# Cherry Street Lakefilling and Design

June 21, 2017

# **Cherry Street Lakefilling Design Review Submission**

<b>Design Review Panel Consensus Comments</b>	<b>Proponent's Response</b>
1. MT35 building preservation is supported – further explore how vegetation dissolves into the structure.	1. Due to the recent fire on 05/25 this has not been advanced. Further advancement of this item will be addressed in Promontory Park Schematic Design Phase.

**Promontory Park North - Connectivity Diagram Proposed**

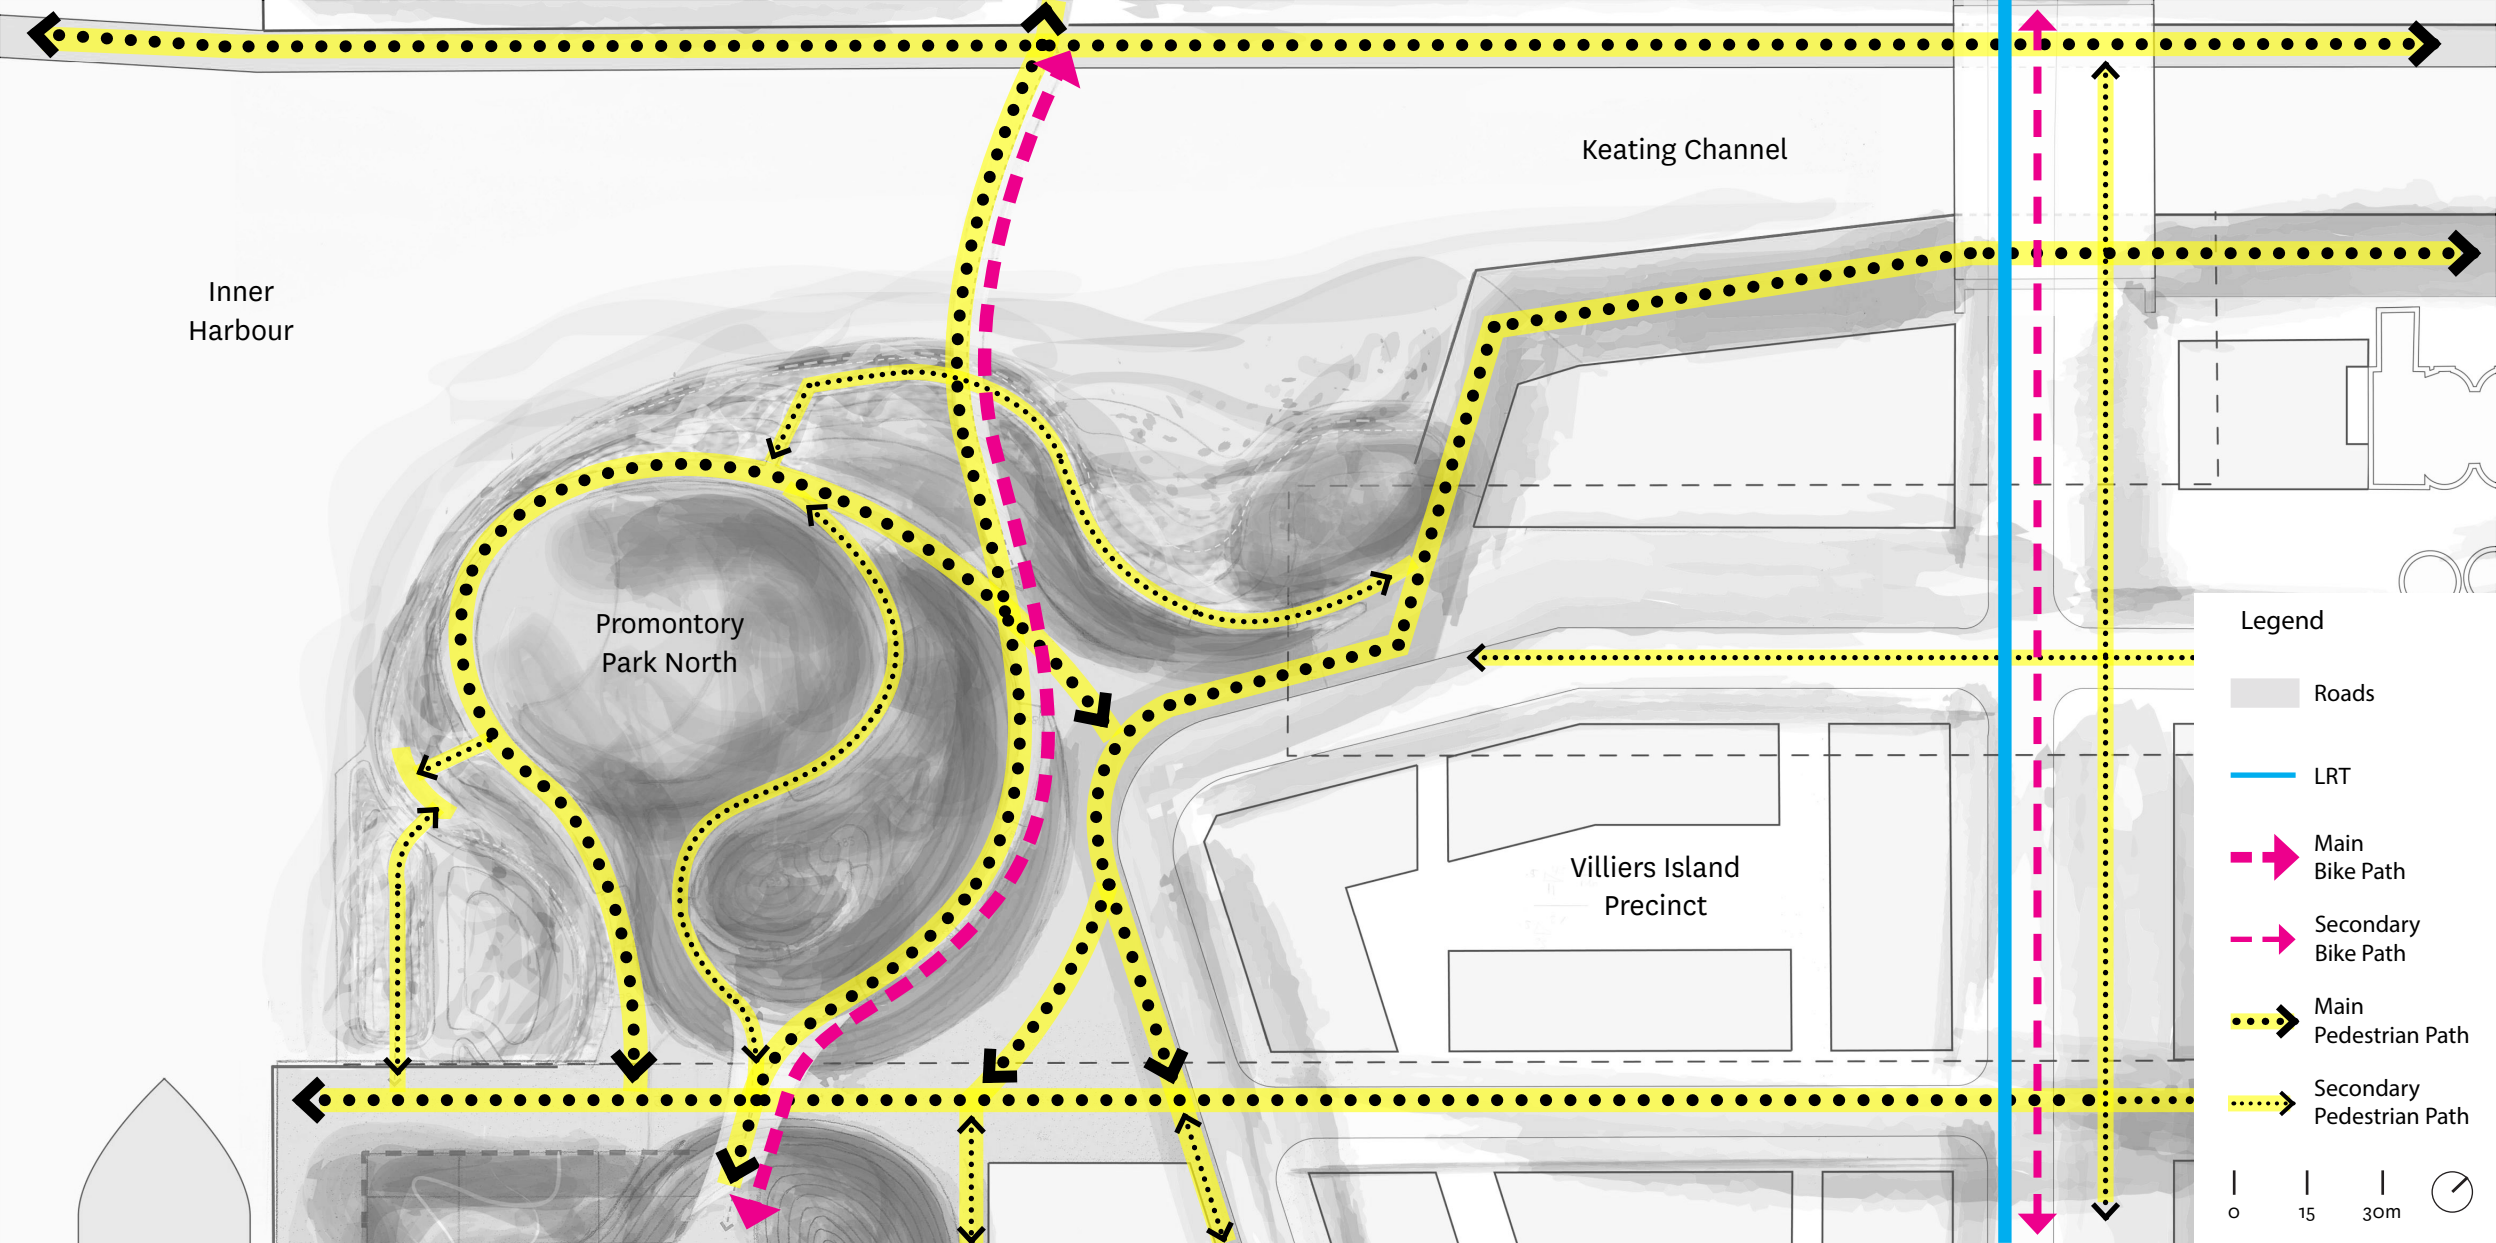
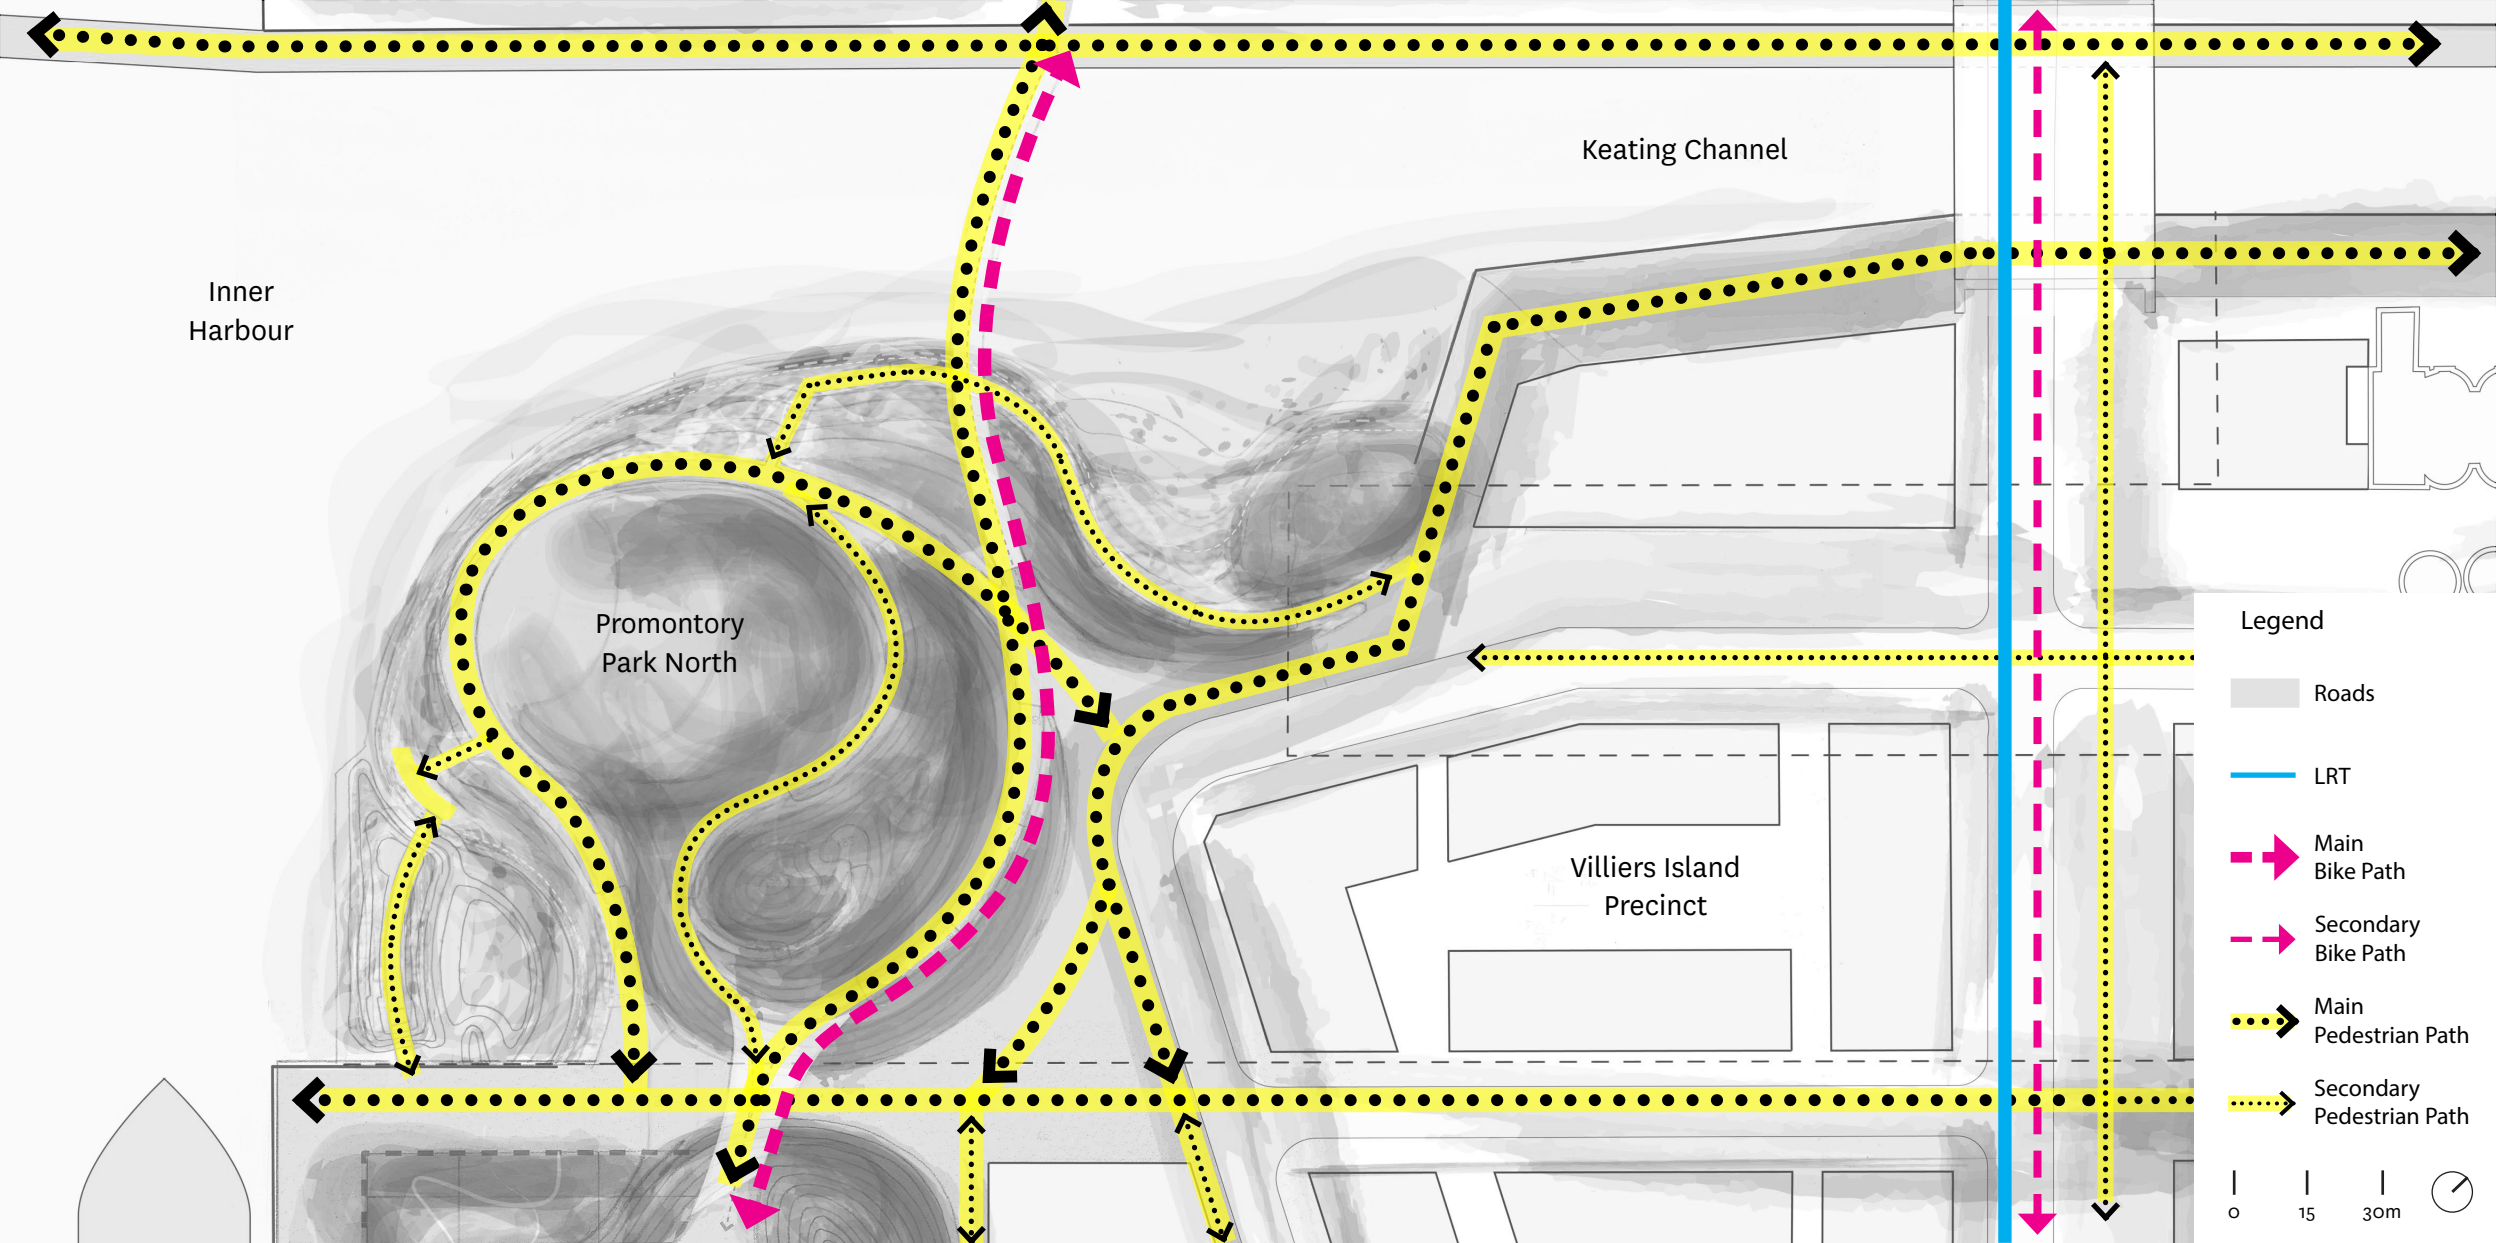
2. Views back to the City, Lake and the neighbourhood are all critical – refine how the linear and curved features of the park elements will enhance the views.	2. Further advancement of this item will be addressed in Promontory Park Schematic Design Phase.

**West Habitat Cove - Enlargement Plan**

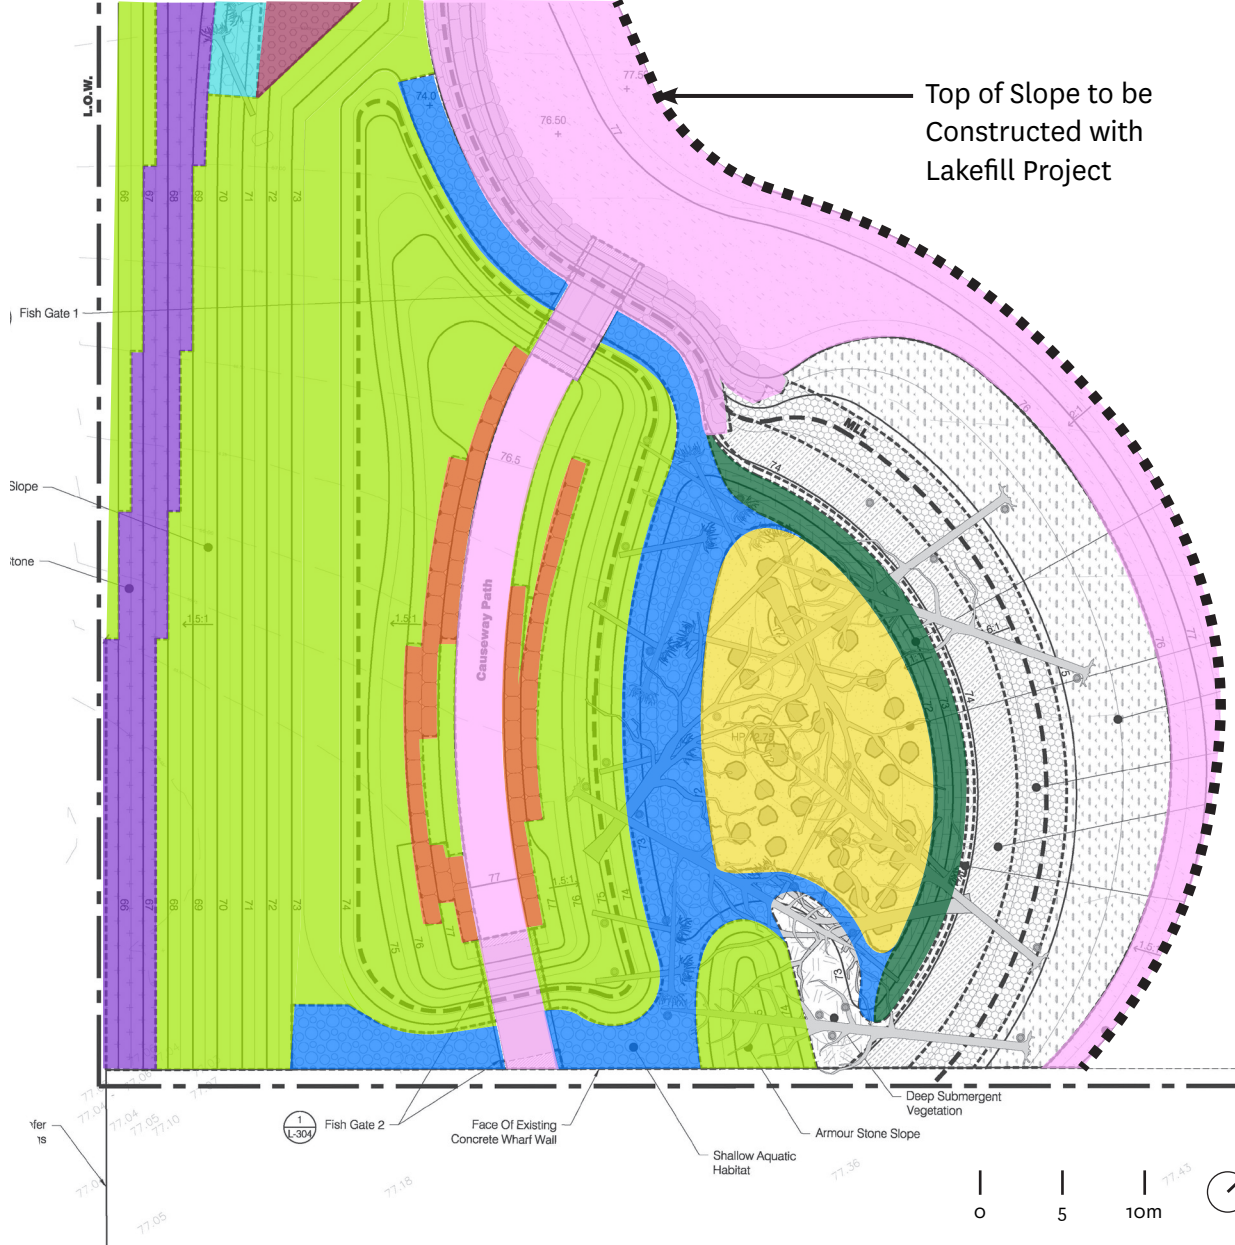
3. Think about how the cove meets the wall including size, placement, integration of soft landscape with hard stone armour.	3. The design and alignment of the rocky causeway has been modified to resemble the language of the rest of the park. The stone size at the armour slope has been reduced and dimensional stones have been incorporated for water access. The vegetated area at the east side of the West Cove has been expanded.
